## ADDENDUM NO. 3

Reference: Recreation Rehabilitation Phase 1 – Starvation State Park  
Division of Parks and Recreation – Duchesne County, Utah  
DFCM Project No. 08085510

Subject: **Addendum No. 3**

CENTRAL UTAH PROJECT  
BONNEVILLE UNIT - UTAH  
**STARVATION STATE PARK**  
RECREATION REHABILITATION - PHASE I  
FINISHED SITE PLAN

U.S. DEPARTMENT OF THE INTERIOR  
BUREAU OF RECLAMATION  
CENTRAL UTAH PROJECT  
BONNEVILLE UNIT - UTAH  
**STARVATION STATE PARK**  
RECREATION REHABILITATION - PHASE I  
**6 - UNIT FLUSH RESTROOM WITH SHOWERS**  
ROOF FRAMING AND ELECTRICAL PLANS

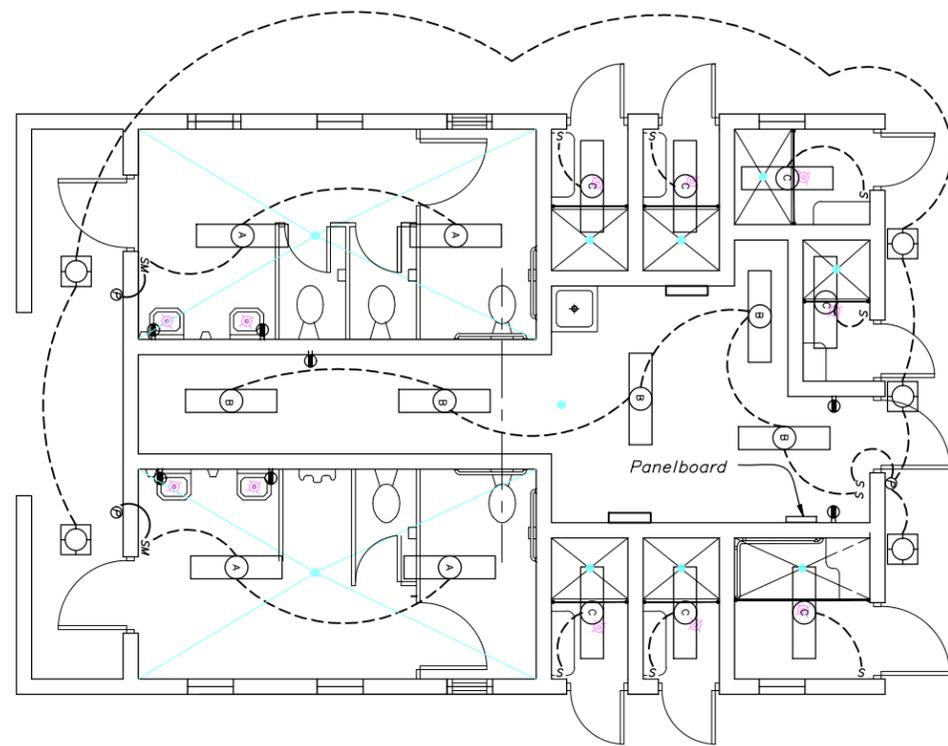
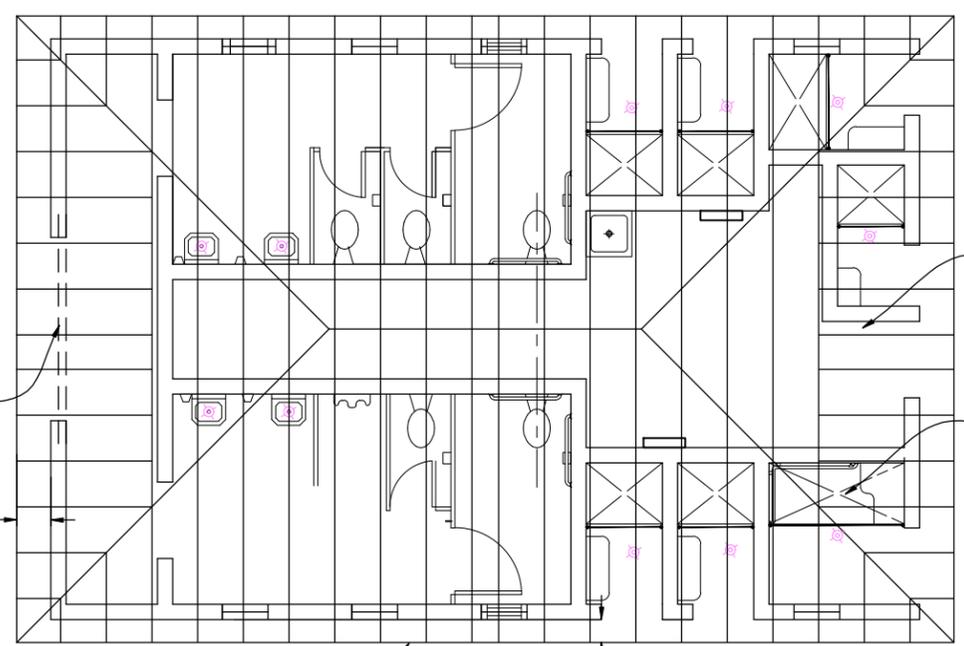
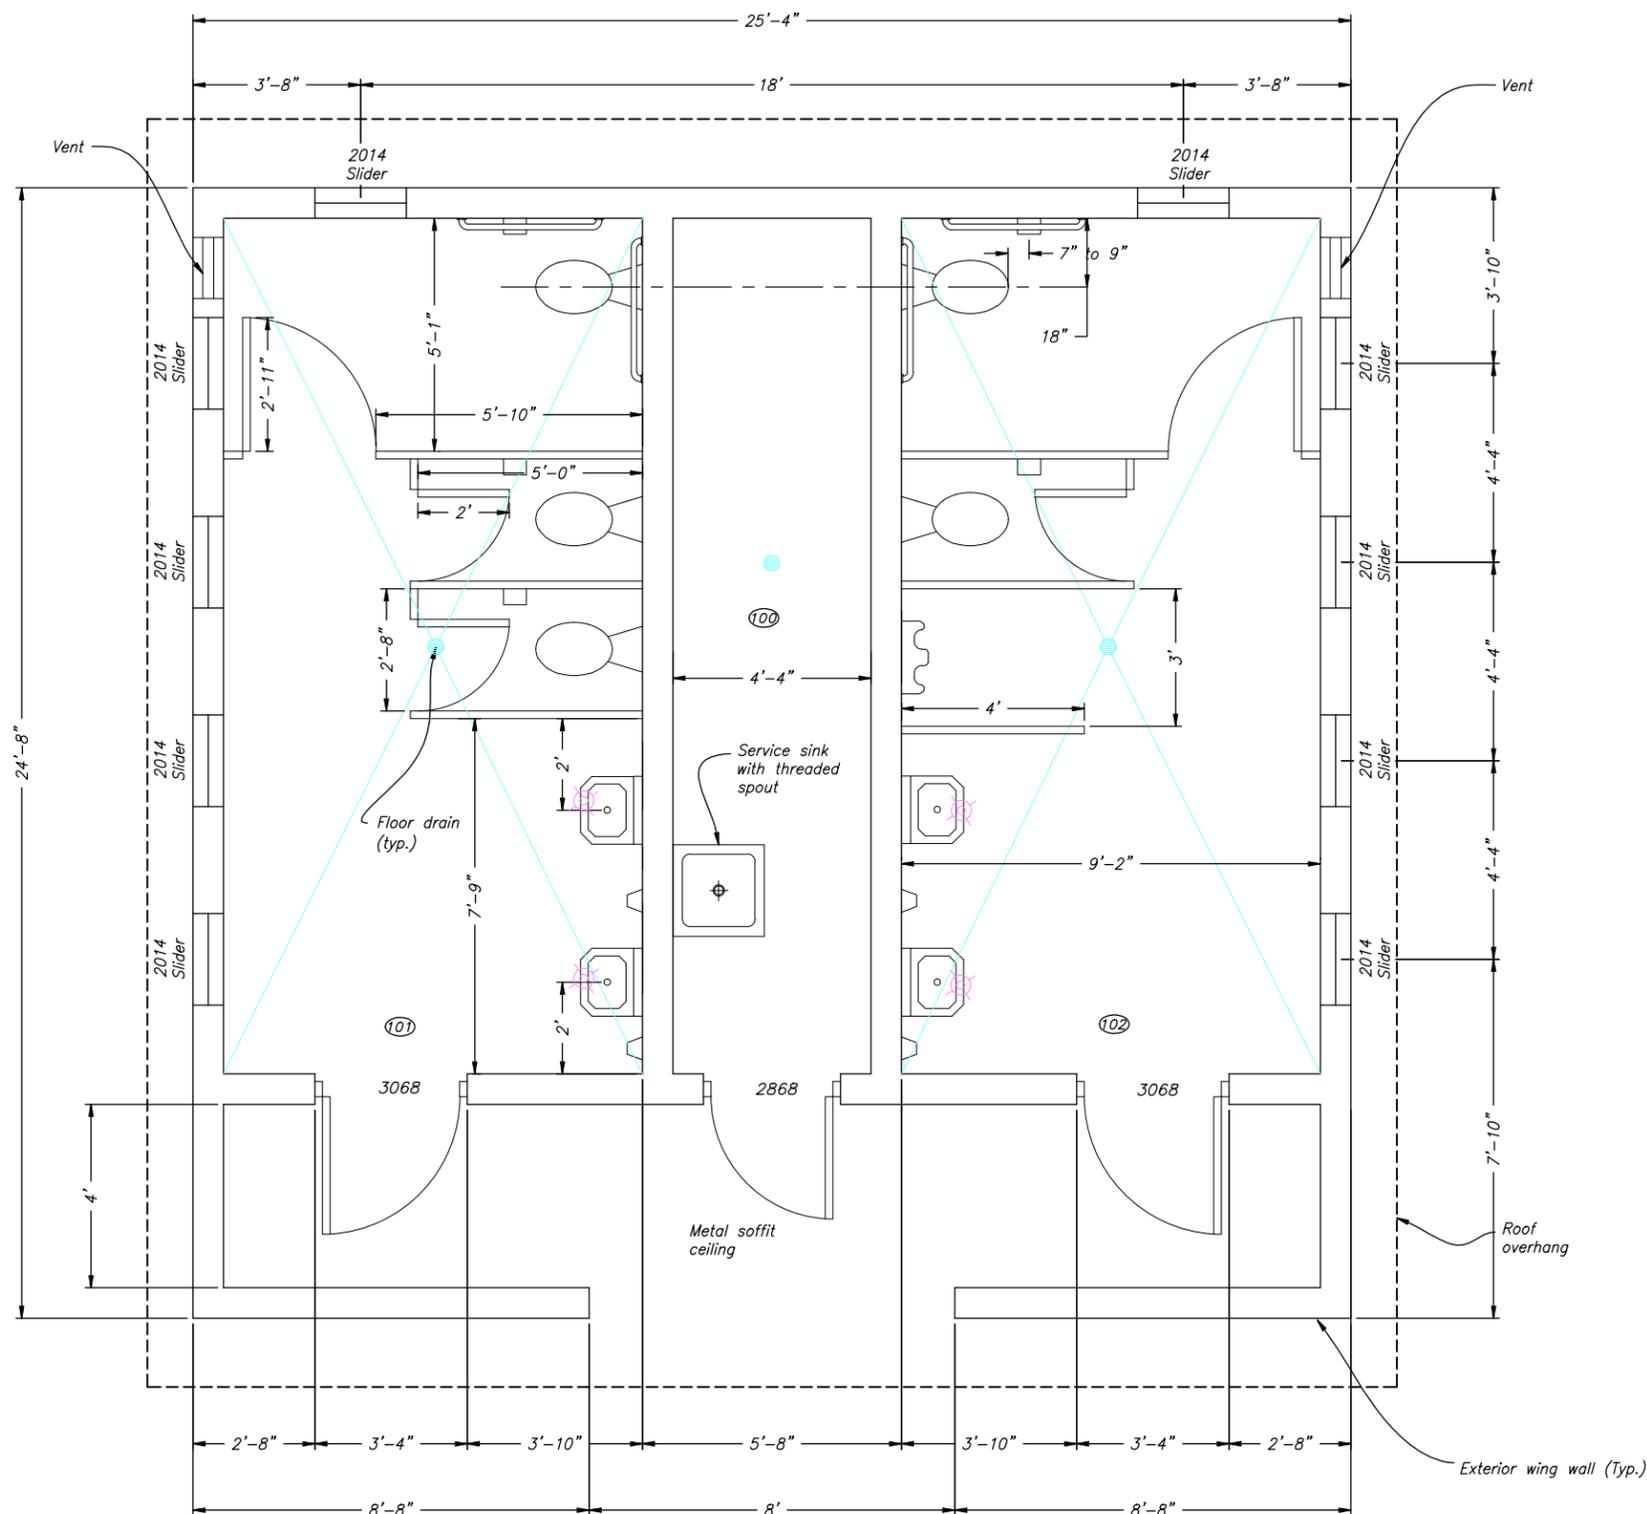
1. Please confirm both the Electric Hand dryers as well as the Electric water heaters are to receive power (not shown on the plans, but shown on the panel schedule). Please confirm a total of 4 electric hand dryers for this project.

6. We need to know the location of the new LP panel inside the new building.

- Answer - This has been added to drawing.*
7. It is our understanding that the new LP panel will be in the 6 unit flush restroom with showers. How is the 6 unit flush restroom getting power? Is there another panel? How is it fed?  
*Answer - There is also to be a new panelboard in the new 6-unit flush restroom. The location of the panelboard has been added to the drawing and the Contractor is responsible to size it and determine all the circuits. The restroom with showers had additional detail shown in the drawings because of the distribution to the campground power pedestals.*

2010-06-22  
400  
1  
JBY  
Added notes 4 & 5. Added hand dryer symbol. Added panelboard location.
